SUNDRY NOTICES AND REPORTS ON WELLS (DO NOT USE THIS FORM FOR PROPOSALS TO DRILL OR TO DEEPEN OR PLUG BACK TO A DIFFERENT RESERVOIR. USE "APPLICATION FOR PERMIT" (FORM C-101) FOR SUCH PROPOSALS.)		WELL API NO. 30-025-05125
1. Type of Well: Oil Well ☒ Gas Well ☐ Other ☐		5. Indicate Type of Lease STATE ☐ FEE ☒
2. Name of Operator Celero Energy II, LP		6. State Oil & Gas Lease No.
3. Address of Operator 400 W. Illinois, Ste. 1601 Midland, TX 79701		7. Lease Name or Unit Agreement Name Buckley B
4. Well Location Unit Letter D : 990 feet from the North line and 330 feet from the West line Section 25 Township 14S Range 37E NMPM County Lea		8. Well Number 2
11. Elevation (Show whether DR, RKB, RT, GR, etc.) 3812'		9. OGRID Number 247128
		10. Pool name or Wildcat Denton Pennsylvanian

OTHER: Amend P&A procedure ☒

Buckley "B" # 2 - 990' FNL & 330' FWL of Sec. 25, T-14S, R-37E, Unit Letter "D"

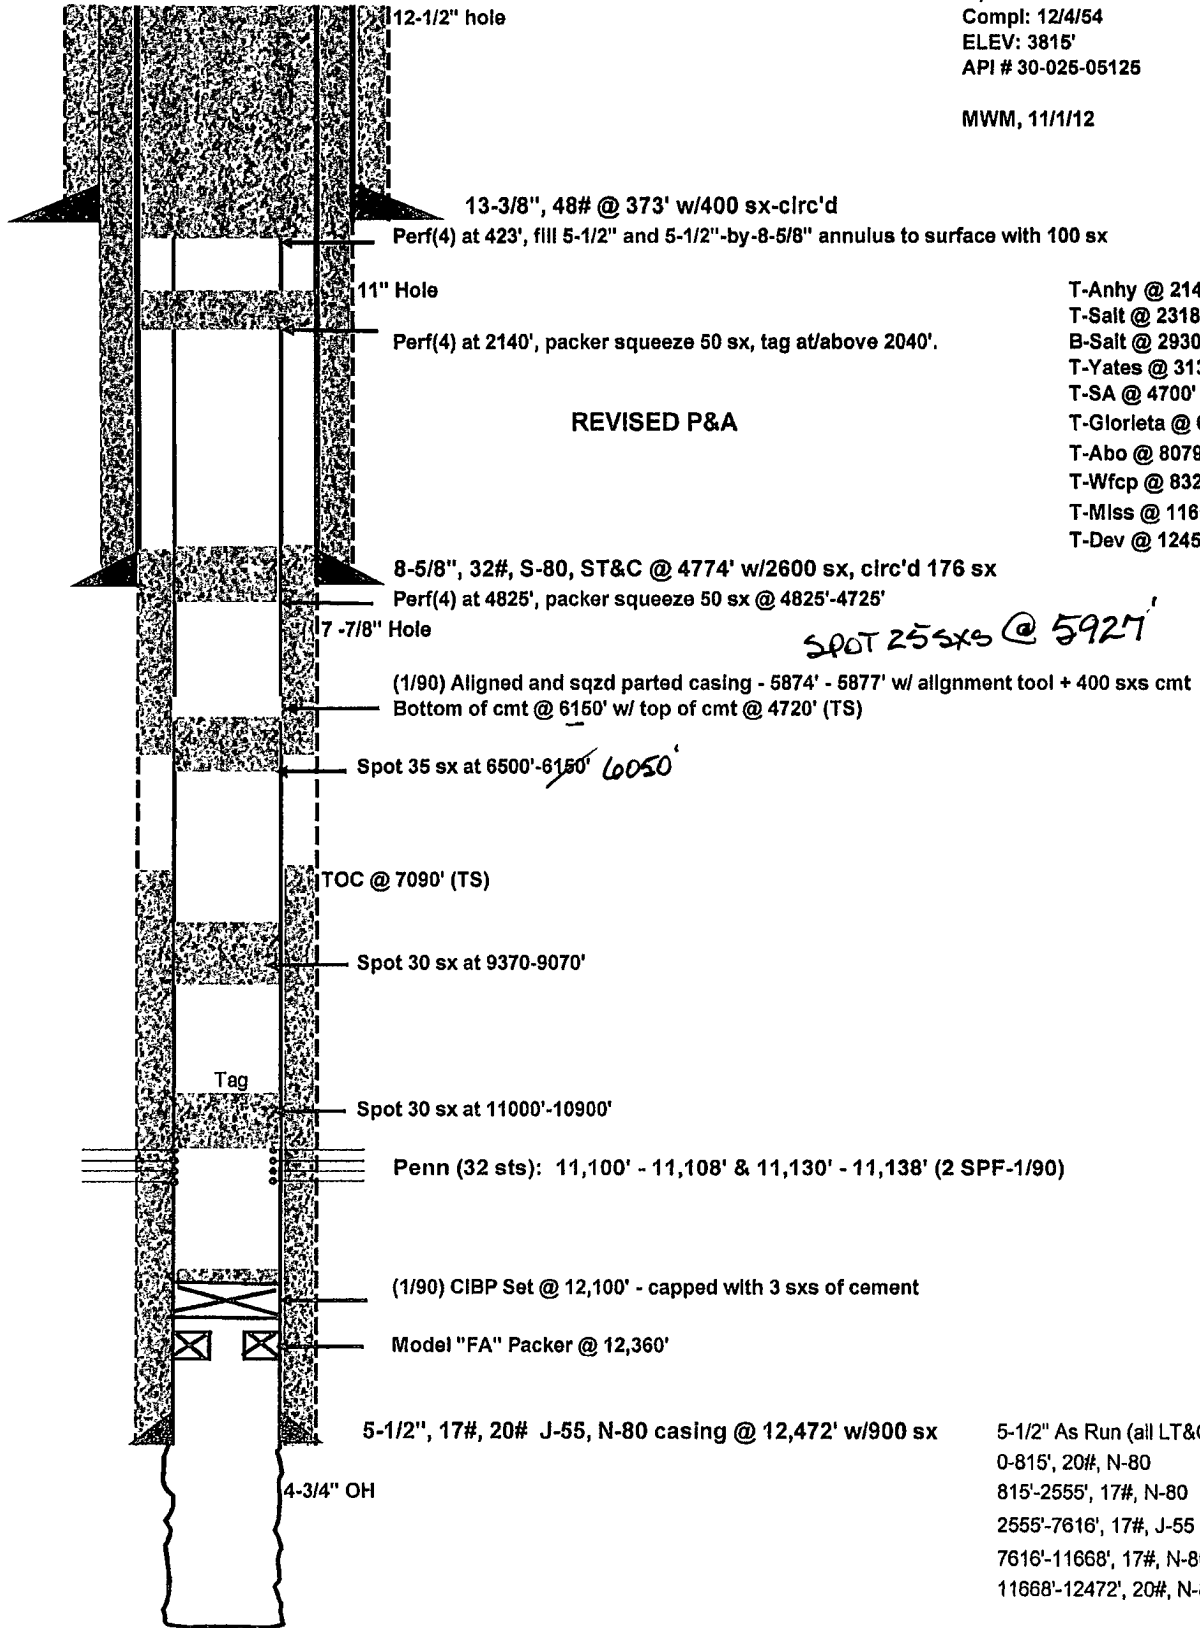
1. RIH w/ BP & PS on 2 7/8" tbg to 11,000' & spot 30 sx. Class C. Pick up, WOC, a min 4 hrs & tag TOC.
2. Circ salt mud to 5300'. Pull tbg to 9370' & spot 30 sx. Pull tbg to 6500' & spot 35 sx. POOH. SPOT CMT - 256xs @ 5927'
3. Perf 4 @ 4825'. RIH w/ pkr & sqz 50 sx. POOH w/ pkr. RBIH w/ BP & PS & tag TOC at/above 4725'. Circ salt mud to 2140' & POOH.
4. Perf 4 @ 2140'. RIH w/ pkr & sqz 50 sx. POOH w/ pkr. RBIH w/ BP & PS & tag TOC at/above 2040'. Circ salt mud to 423' & POOH.
5. Perf 4 @ 423'. Fill 5 1/2" & 5 1/2" by 8 5/8" annulus to surf w/ min 100 sx.
6. RD. Set P&A marker, clean & reclaim location.

All plugs Class C cmt.

Min 9.5 ppg salt mud between plugs.
